MONTICELLO NUCLEAR GENERATING PLANT  
Docket No. 50-263 License No. DPR-22

Request for Relief No. 11 for the 3rd 10-Year Interval Inservice Inspection Program

#### Request for Relief No. 11 for the 3rd 10-Year Interval Inservice Inspection Program Clarified Sketches and Weld Identification Numbers

## Reactor Vessel Nozzle N-3B NV

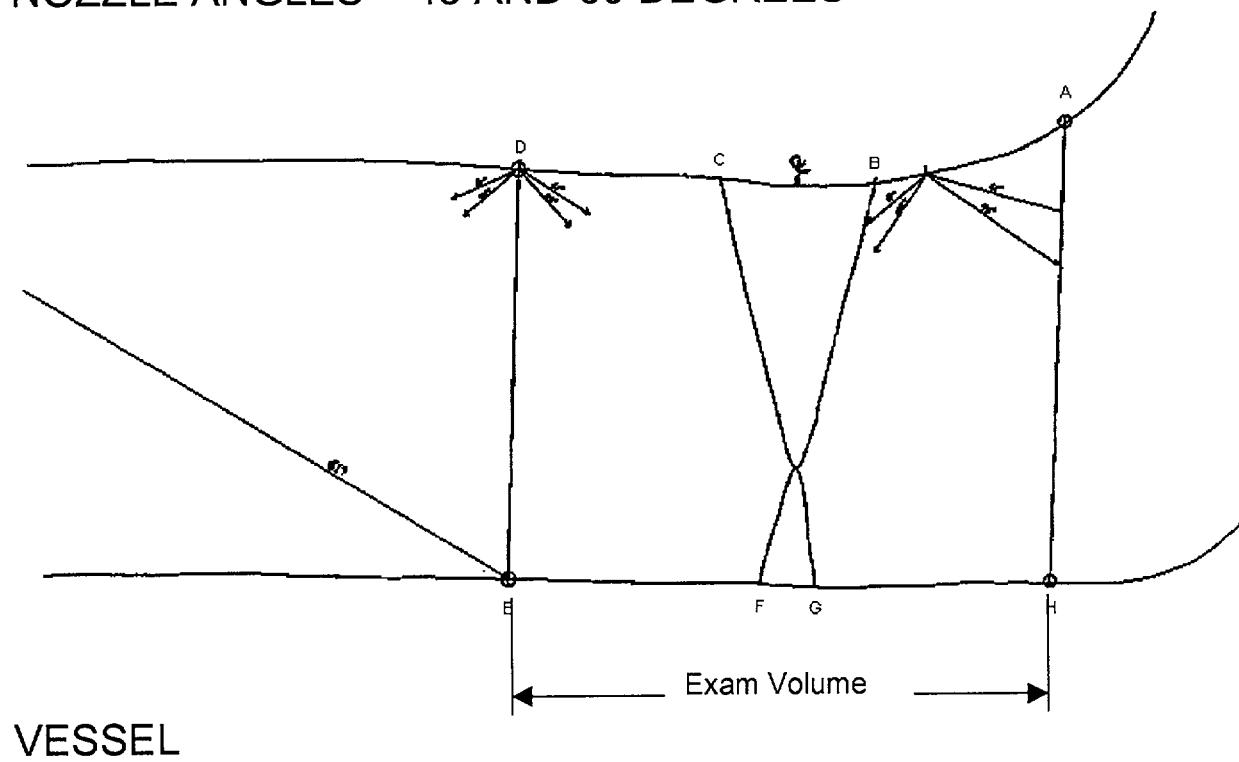
1. NRC Request: Provide better sketches and/or illustrations for Figures 2, 3, 4, and 6.

NSP Response: Clarified sketches are attached.

Coverage for nozzle/vessel weld is 61.27% Inspection limited due to nozzle configuration.
